Public Works Department

Addendum No. 1

Date: **10/27/2026**
To: **Plan Holders**
Prepared By: **Brendan Patton,**
Subject: **Notice to Bidders Revision, 2026/27 W Michigan Ave Sidewalk Improvement**

MICHIGAN AVE SIDEWALK PROJECT 2026/27 S GAINES TO S STEPHEN

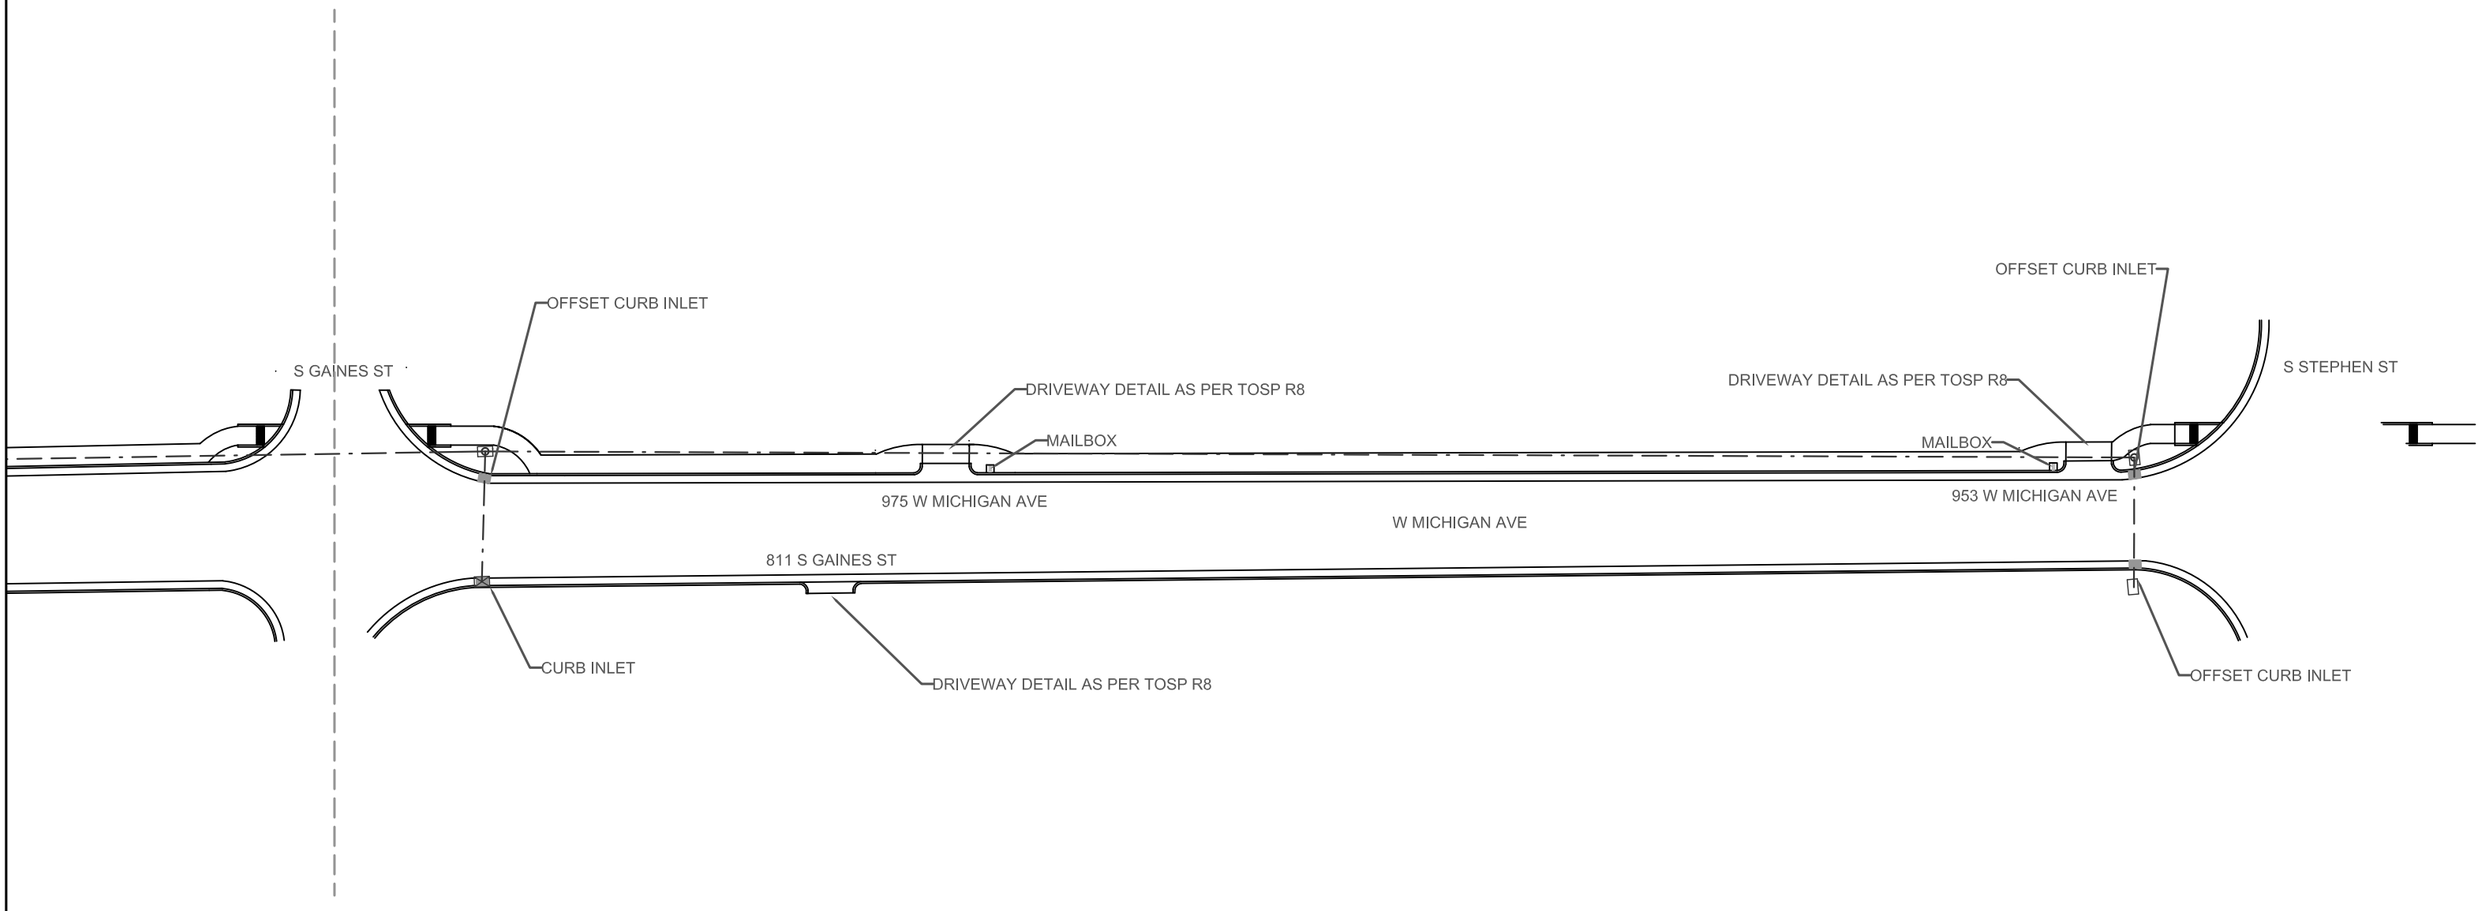
9. Catch Basin Locations – 6 number in total
   There are five NCDOT flumes to be installed as per NCDOT detail. The catch basins are existing along with drainage. One Catch basin to receive grate and hood. Pay item description below drawings also attached.

Description: Furnish all labor, materials, equipment, and incidentals necessary to modify an existing catch basin and construct an offset inlet in accordance with the approved plans and the attached proposed offset catch basin detail.

Measurement and payment: The work will be measured by the number of existing catch basins modified and accepted. The contract unit price per each shall be full compensation for the work described above.
